Technical Service Bulletin: TSB260059

Low-Temperature Aftercooler (LTA) Accessory Drive Housing Improvement

Figure 1, Example of Rough Sealing Surface on Accessory Drive

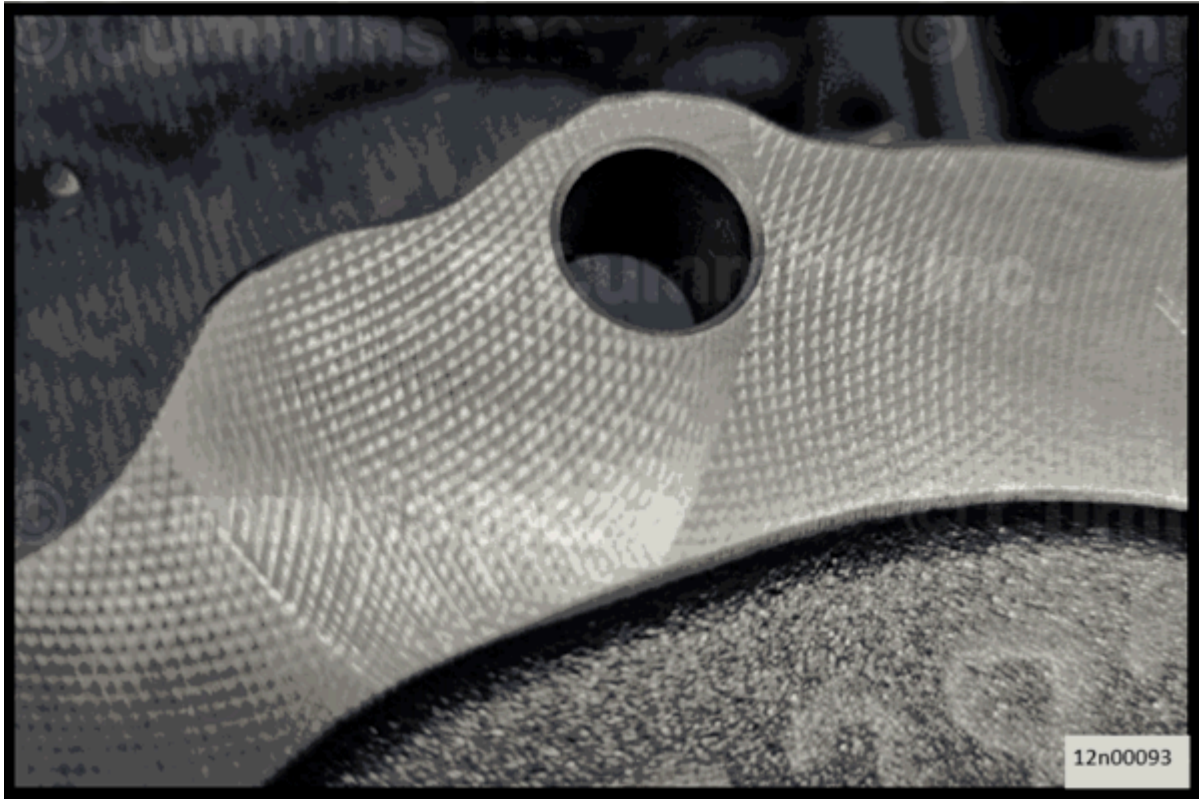
- Press in place seal installed incorrectly.
- Surface finish of offset accessory drive mating surface machined incorrectly.

Inspect offset accessory drive and LTA water pump drive for damaged threads and excessively rough sealing surfaces. Replace any damaged components. Replace press in place seal. Verify that press in place seal is fully seated in seal groove.
